ND-14-0513
10 CFR 50.90

Southern Nuclear Operating Company
Vogtle Electric Generating Plant Units 3 and 4
Request for License Amendment:
Auxiliary Building Structural Floor Details (LAR-14-003)

Southern Nuclear Operating Company
Vogtle Electric Generating Plant (VEGP) Units 3 and 4

UFSAR Chapter 3, Appendix 3H, Figure 3H.5-1 (Sheet 2 of 3) [*Nuclear Island Critical Sections Plan at El. 180'-0"*]* - Revise Tier 2* information as shown in the figures following this page.

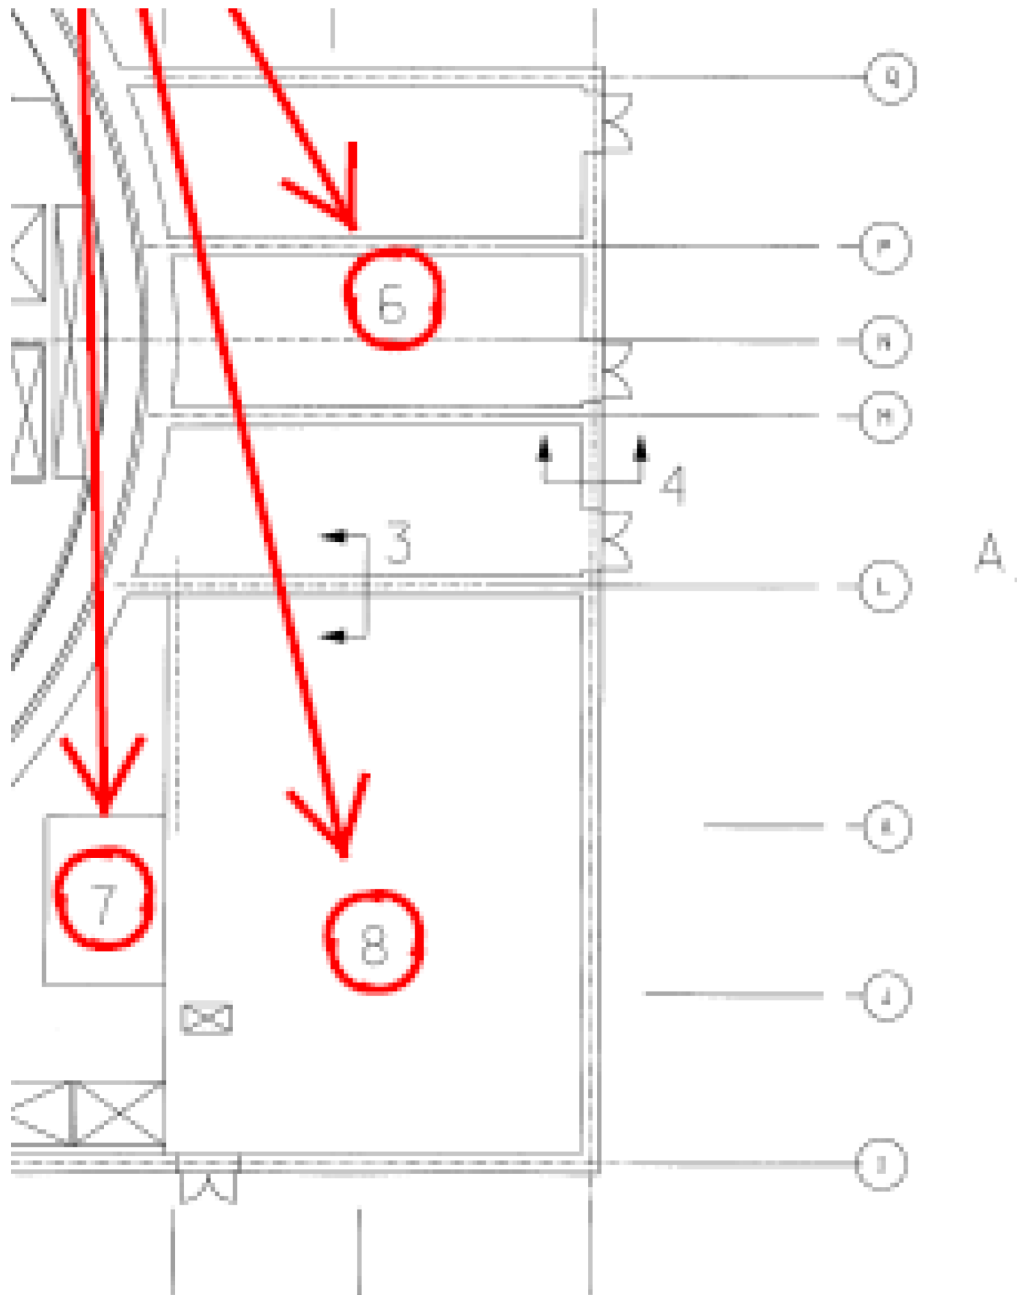
- 3. On Sheet 1 between column lines 7.3 and 9.2 change the "8" label to "7"
 - 4. On Sheet 2 Move the arrows for Item 5 to near the intersection of wall N and the shield building cylinder wall.

- 5. On Sheet 2 between column line N and K-2 change the "6" label to "5"
 - 6. On Sheet 3 at elevation 135'-3" change the "7" to "6"
 - 7. On Sheet 3 at the intersection of the shield building roof and the outer tank wall change the "10" label to "9"

UFSAR Figure 3H.5-1 (Sheet 1 of 3) markup

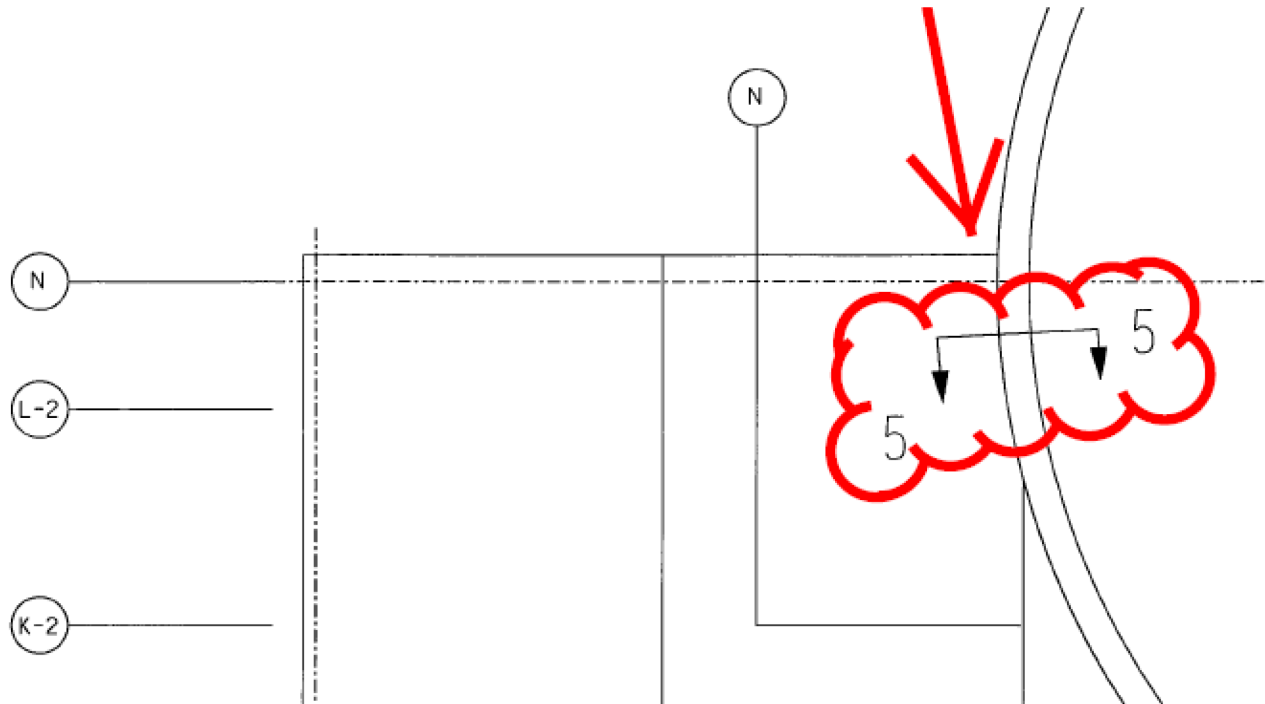
- H. UFSAR Figure 3H.5-1 is revised as follows:
 - 1. On Sheet 1 between column lines M and P change the "7" label to "6"
 - 2. On Sheet 1 between column lines I and L change the "9" label to "8"

8. On Sheet 3 at the intersection of the shield building roof and the inner tank wall add a circle and label it "10"

The labels for the designation of the critical sections on UFSAR Figure 3H.5-1 are changed to match the item numbers in the list in UFSAR Subsection 3H.5.1. A new label for Item 10 is added to the figure.

UFSAR Figure 3H.5-6 markups

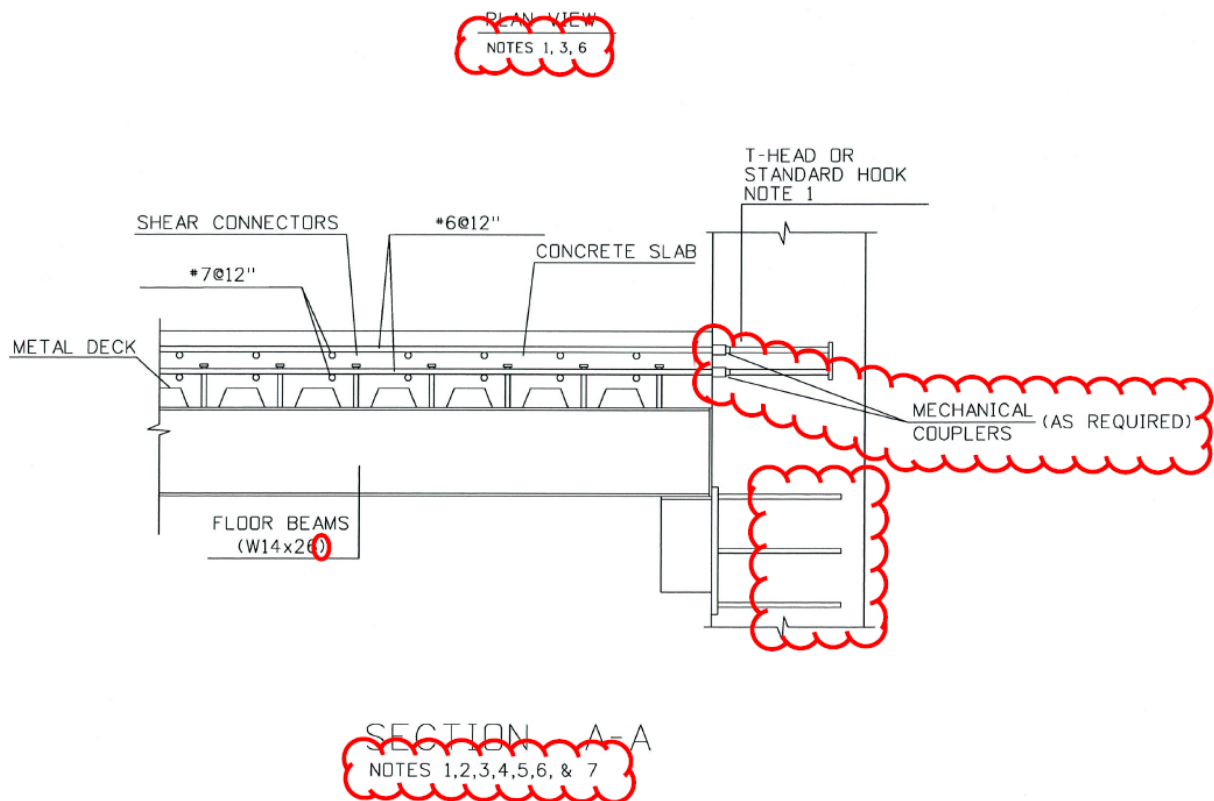
I. UFSAR Figure 3H.5-6 is revised as follows:

1. In Section A-A; remove the "TYP" from the W14x26 floor beam designation consistent with adding the notes
2. Revise the representation of the beam support to show deformed wire anchors embedded in the wall instead of headed studs

3. In Section A-A, add a designation "Mechanical Couplers (As Required)" to the reinforcement couplers shown at the interface of the floor and wall
4. To the Label "PLAN VIEW" add "Notes 1, 3, 6"

5. To the Label "SECTION A-A" add "Notes 1, 2, 3, 4, 5, 6, & 7"
6. Move note 1 to the new list of notes and renumber to Note 2
7. Add the following notes to the figure

Changes to UFSAR Figure 3H.5-6 remove the designation of the floor beam size as typical (TYP). The representation of the beam supports is changed to show use of deformed wire anchors embedded in the concrete. Notes are added to define the variations in other similar floor sections from the critical section design shown in the figure. The notes are described below in the Licensing Basis Change Description. The design of the critical section depicted in UFSAR Figure 3H.5-6 is unchanged.

UFSAR Figure 3H.5-8 markups

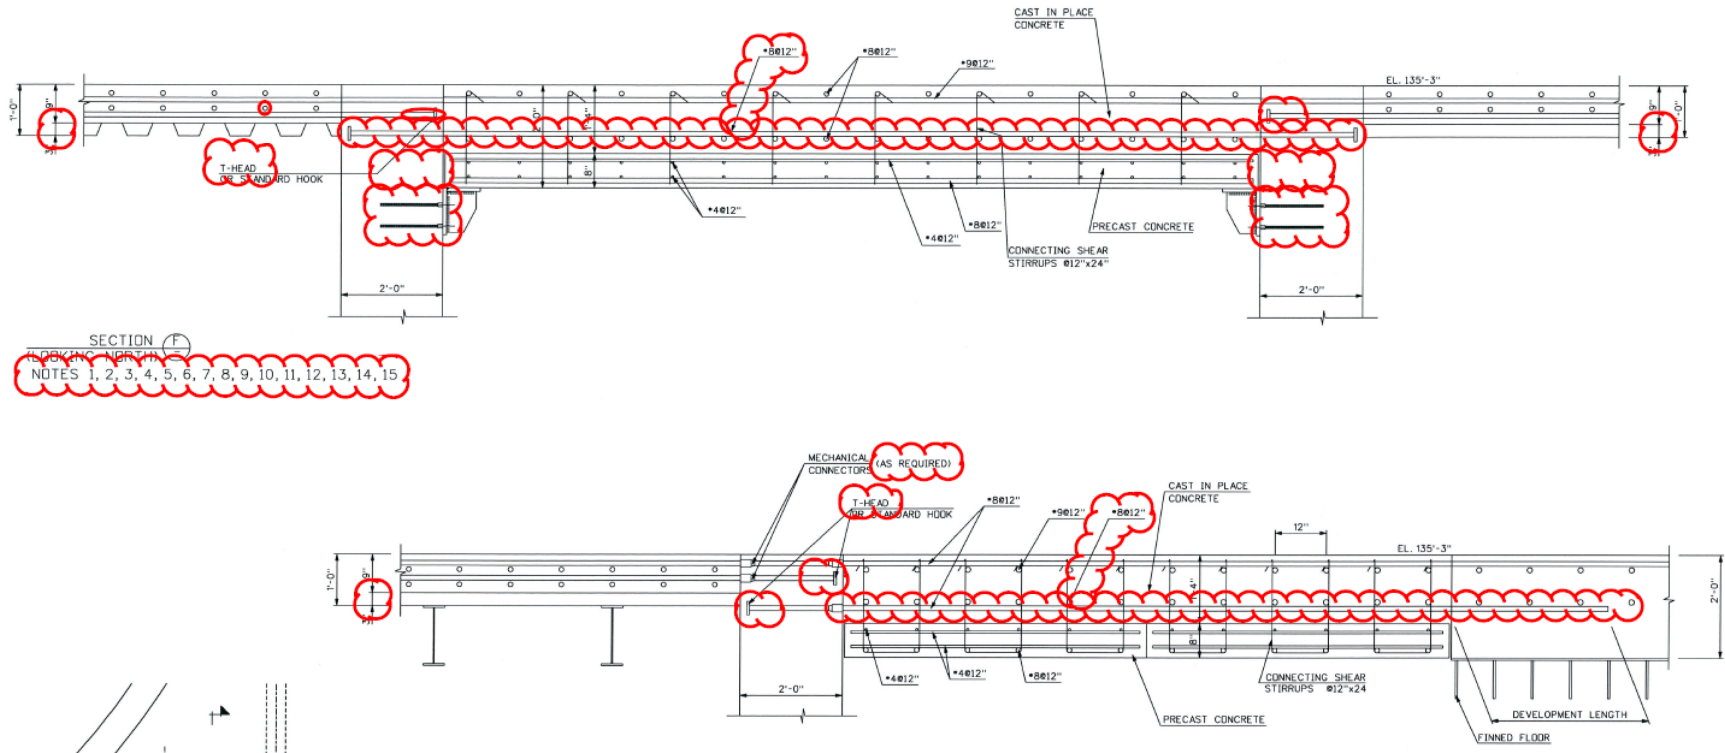
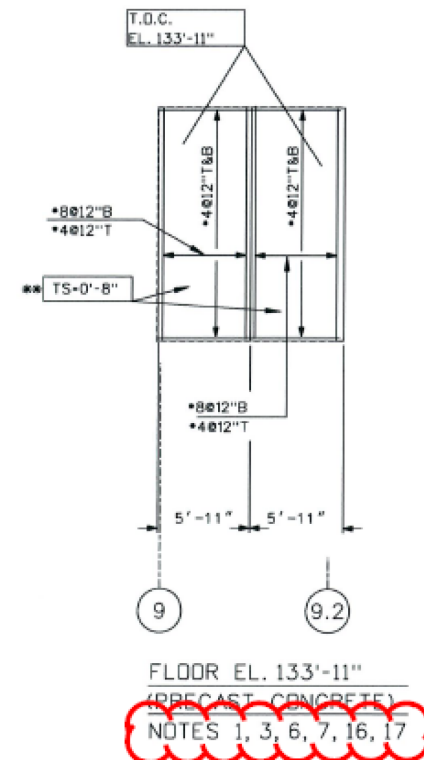
J. UFSAR Figure 3H.5-8 is revised as follows:

1. In Section F Looking North, replace the bottom #8@12" reinforcement bar extending into the walls with a bar that is contained within the precast panel.

2. In Section F Looking North, add a #8@12" reinforcement bar extending into the walls with headed reinforcement to the lower portion of the cast-in-place concrete. Add a label to this bar identifying the #8 @ 12" reinforcement arrangement.

3. In Section F Looking North, extend the length of the reinforcement bars terminated with headed reinforcement
4. In Section F Looking North, on the left side of the section view, replace "Anchor Plate" with "T- Head"

5. In the floor in the left side of the Section F View shift the misplaced small circle representing a north south reinforcement bar to the correct location above the east west rebar.

6. At each end of the Section F View the drawing convention to define the 3" distance is changed to move the arrows.
7. In Section F Looking North, revise the representation of the panel support to show deformed wire anchors embedded in the wall instead of headed studs.

8. To the Label "Section F Looking North" add "Notes 1, 2, 3, 4, 5, 6, 7, 8, 9, 10, 11, 12, 13, 14, 15"
9. In Section C Looking West, extend the length of the reinforcement bars terminated with headed reinforcement

10. In Section C Looking West, add designation of perpendicular longitudinal reinforcement above lower reinforcement bar in cast-in-place concrete and add arrow from "#8@12'" to rebar.

11. In Section C Looking West, replace "Anchor Plate" with "T-Head"
12. In Section C Looking West, add "(As Required)" to the designation "Mechanical Couplers" for the reinforcement couplers shown at the interface of the floor and wall

13. At the left end of the Section C View, the drawing convention to define the 3" distance is changed to move the arrows.
14. To Label "Section C Looking West", add "Notes 1, 2, 3, 4, 5, 6, 7, 8, 9, 10, 11, 12, 13, 14, 15"

15. In FLOOR EL. 135' 3" view, add "#8@12 B" for Bottom rebar.
16. To Label FLOOR EL. 135' 3" add "NOTES 1, 5, 7, 9, 13, 15"
17. To Label FLOOR EL. 133' 11" add "NOTES 1, 3, 6, 7, 16, 17"

UFSAR Figure 3H.5-8 is revised to change the representation of the flexural reinforcement design shown in the figure. The original figure shows reinforcement extending from the precast panel into the adjacent wall. This design is changed to support construction sequencing in which the concrete for the walls is placed before the precast panel is put in place. The figure is changed to show the reinforcement terminating within the precast slab and reinforcement added to the bottom of the cast-in-place portion. This additional reinforcement in the cast-in-place portion extends into the wall. The figure is also changed to fix discrepancies with drawing convention to show thicknesses in adjacent floors. The representation of the panel supports is

changed to show use of deformed wire anchors embedded in the concrete. In the plan view of the floor the bottom reinforcement (#8@12") is added. Notes are added to define the variations in other similar sections from the critical section design shown in the figure. The notes are described below in the Licensing Basis Change Description.

UFSAR Figure 3H.5-8 is also changed to modify the location of the T-Heads on headed reinforcements to be consistent with the criteria for development of headed reinforcement. The description on the figure for the anchoring of reinforcement is changed from Anchor Plate to T-Head to accurately reflect the use of headed reinforcement. A note referring to UFSAR Subsection 3.8.4.4.1 for the requirements for development of headed reinforcement is added to the figure. These criteria use ACI 318-11, Section 12.6 requirements and have been previously approved and incorporated into the licensing basis as part of the license amendment to include the use of headed reinforcement above the basemat. UFSAR Subsections 3.8.3.5, 3.8.4.4.1, and 3.8.4.5.1 of the licensing basis were previously revised with a license amendment request to incorporate these criteria. See SNC VEGP COL Amendments 5 and 9 (Adams Accession Numbers ML13056A437 and ML13122A068, respectively). The figure is also changed for consistency with drawing conventions.
